## PROVIDENCE HOSPITAL AND MOB CONNECTOR SP #07-54

### **PROVIDENCE HOSPITAL AND MOB CONNECTOR, SITE PLAN NUMBER 07-54**

### **Planning Review**

Providence Hospital and MOB Connector  
SP #07-54

PROJECT LOCATION  
CONNECTOR

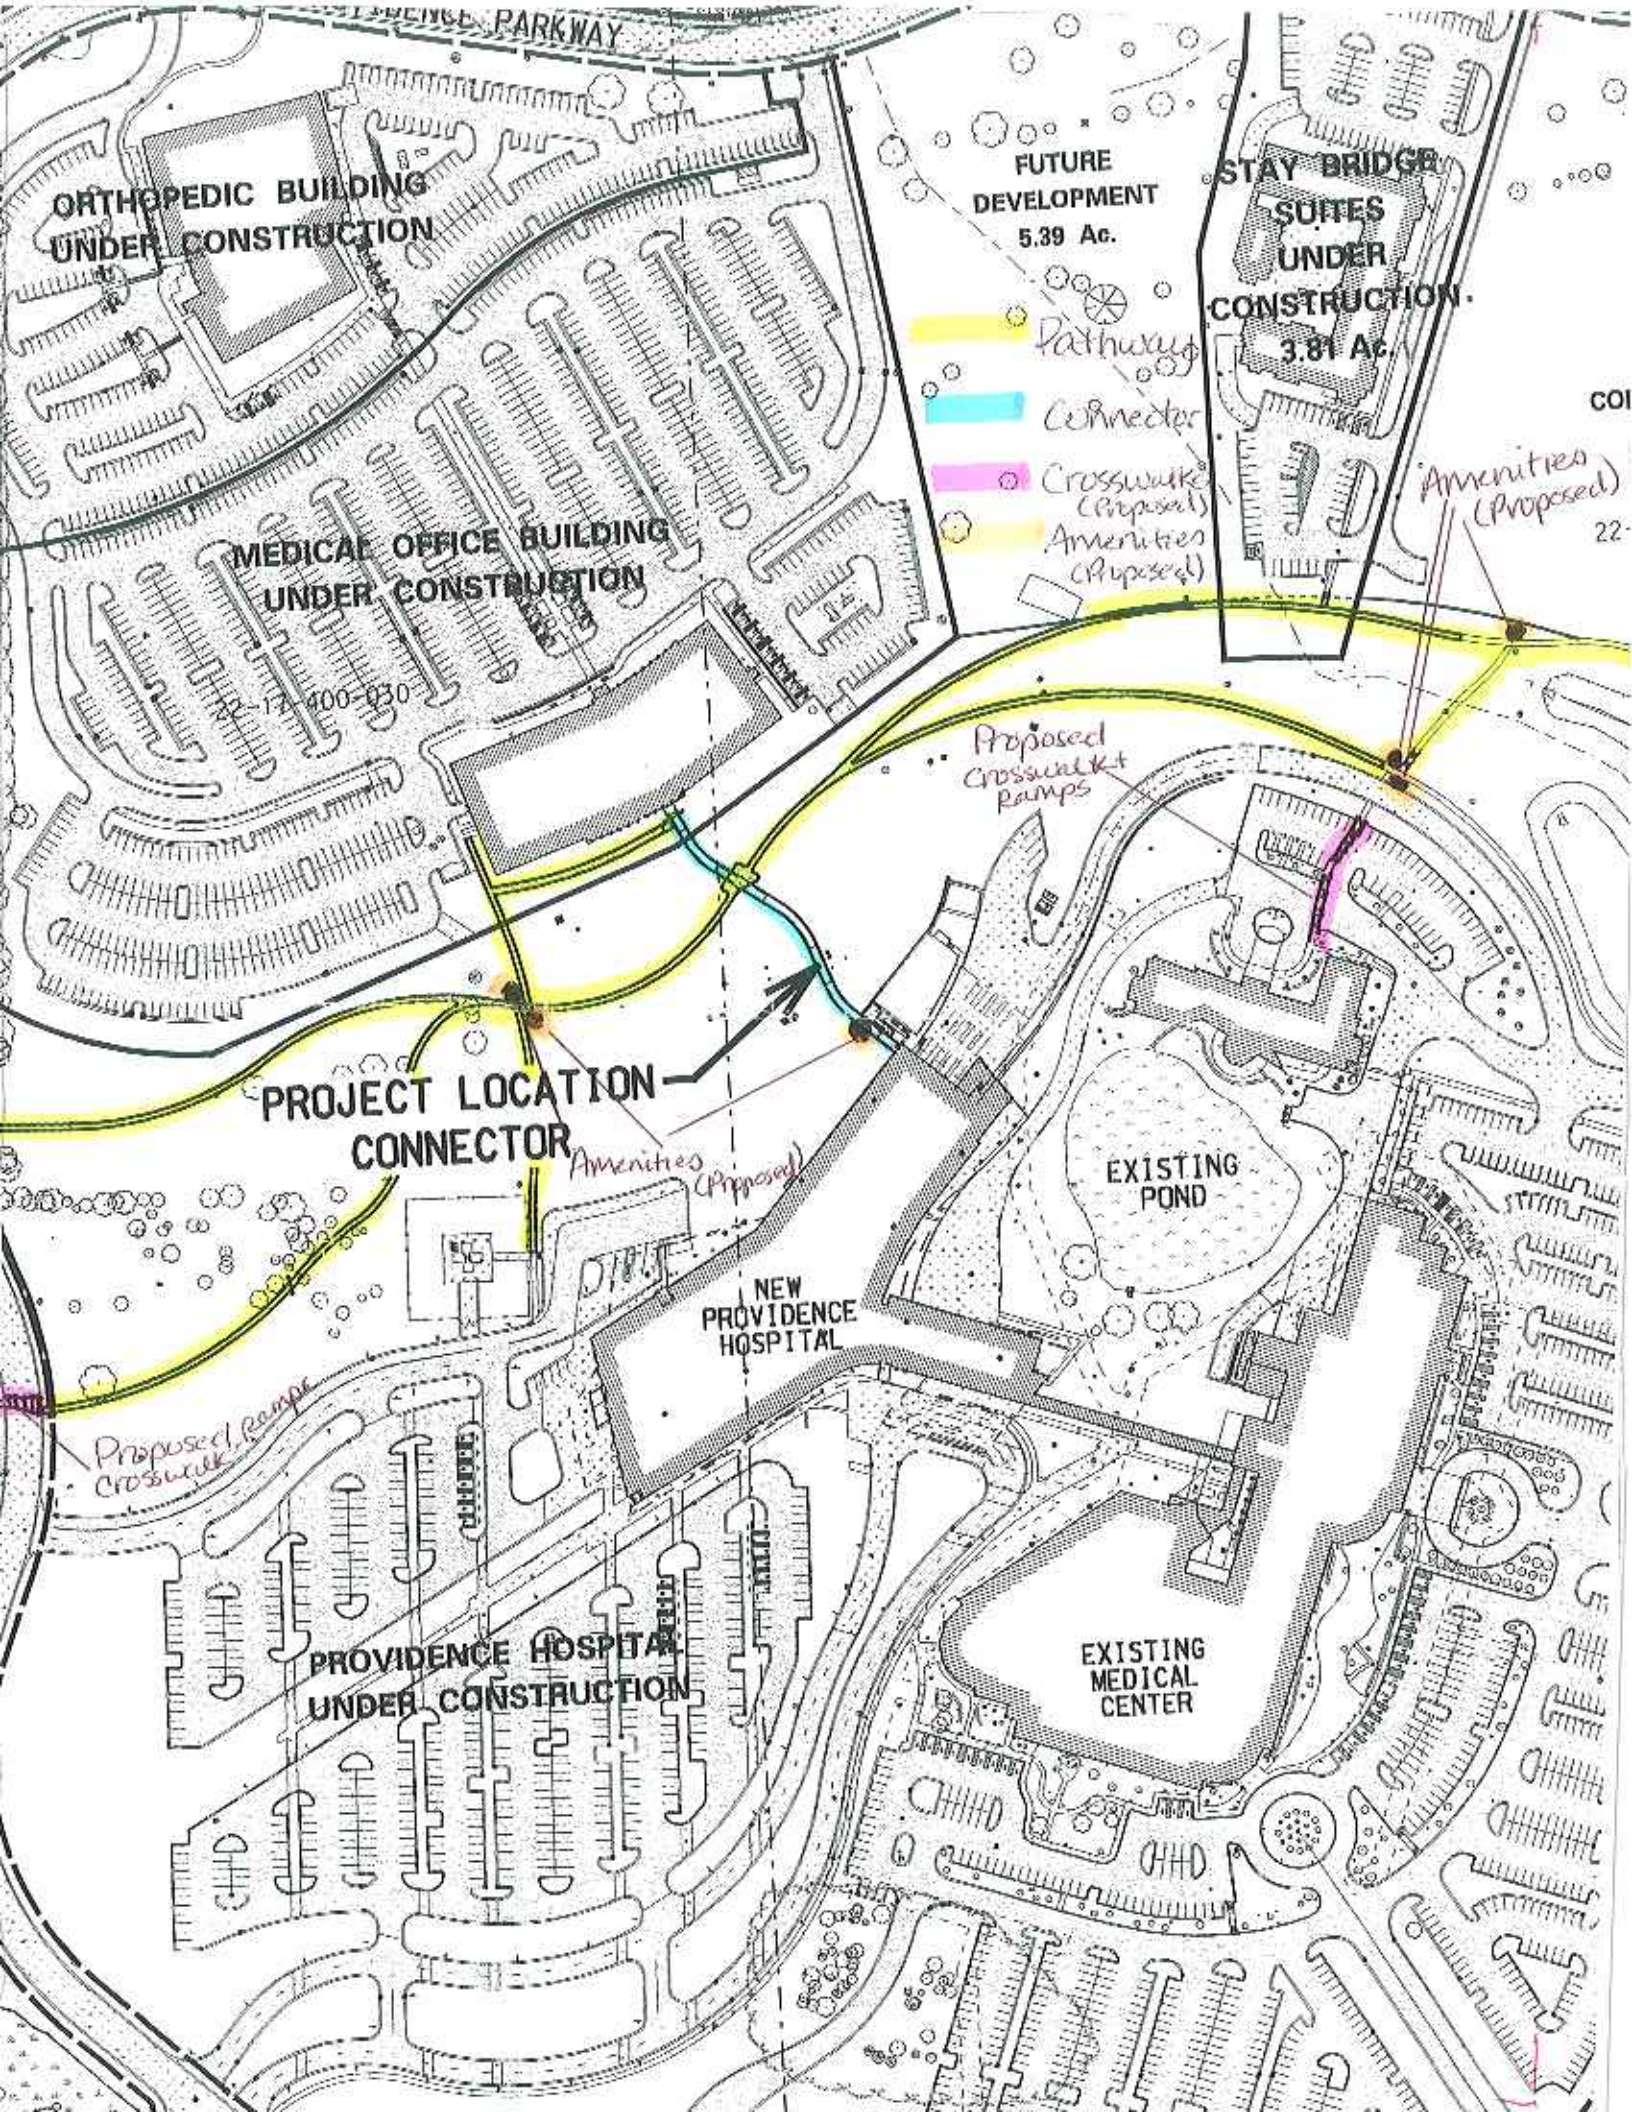
- a. We highly recommend installing a bench and trash can at each of the three pathway extensions between the Assarian Cancer Center and the future commercial/retail site; the two extensions between the Medical Office Building and the helistop; and on the concrete pads adjacent to the exit doors from the connector, near the hospital and its generator building (see attached sheet).

- b. Install a crosswalk from the Assarian Cancer Center to the northern end of the southern parking island, then across the parking lot to connect to the path. Also, we recommend providing wayfinding signs to direct people from the Cancer Center to the pathway, as it may not otherwise be visible to potential users (see attached sheet). We note a slight modification to Assarian's parking lot appears to be necessary to provide a barrier-free access to the pathway. There is an 11.5'-wide striped area near the southern side of the parking lot, which was not included as part of the 51 parking spaces for the lot. The parking spaces could be shifted so the 11.5'-wide area is aligned with the sidewalk ramp and connected to the crosswalk, in order to provide a clearly defined pedestrian access to the pathway. Please see the Traffic Engineering email (dated October 30, 2007,) for additional comments that should be addressed on the plans related to pedestrians crossing the roadway leading to the docks. Also, a crosswalk should be provided across the road to the loading docks. Based on a review of the approved plans for the hospital, it appears sidewalk ramps were previously included from the Assarian Cancer Center parking lot to the pathway.

- c. A wayfinding sign may be appropriate to post at the hospital exit to the connector, in order to direct people through the connector to the Greensward pathway.

Amenities  
(Proposed)

Proposed  
Crosswalk &  
Ramps

Proposed  
Crosswalk  
&  
Ramps
